То:	Matt Clifton
From:	Reymar Victoria, Marina Apfel (WSP)
Subject:	InSitu Manly – Acoustic Impact Assessment (Rev01)
Our ref:	PS131027-101
Date:	24 March 2023

WSP Australia Pty Ltd (WSP) has been engaged to undertake an acoustic impact assessment of the proposed alterations and additions to the outdoor courtyard of InSitu Restaurant and Bar at 18 Sydney Road, Manly (the Project).

This revision of the report has been updated to also addresses the comments made to the by Northern Beaches Council in the Development Application Assessment Report DA2023/0368 in Section 2.

Figure 4.1 Outdoor courtyard layout with existing boundary fence and proposed new building structures

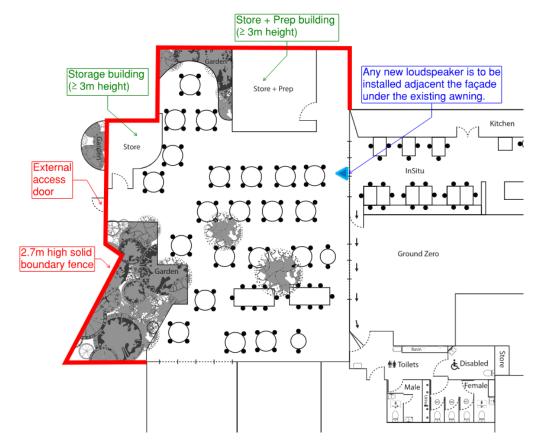
The addition of serving staff in the outdoor area (servery area, wash up, table service)

WSP: We understand that 2 staff will generally be designated to the courtyard and up to 3-4 staff are expected to work in the courtyard at the same time during peak times (including for store room access). To address additional noise from staff in the courtyard we have updated the model to add 2-4 staff to the patron numbers in the courtyard based on the capacity levels (Table 4.2. Please refer to Section 4 for the updates.

- Soft chair furnishing and plant features throughout the courtyard.
- Northern boundary fence to the residential courtyard built with solid construction at ≥ 2.7 m high as shown in Figure 4.1. New access door on the northern boundary fence to be built of solid construction with minimal gaps between the door leaf and frame and no gaps between the door frame and fence.

- New outdoor servery and small storage structures to be built ≥ 3 metre high from solid construction in the locations shown in Figure 4.1. Any noise from equipment installed in the servery such as a fridge and dishwasher has been assumed to be contained within a fully enclosed building structure and therefore not contribute noticeably to the noise emissions.
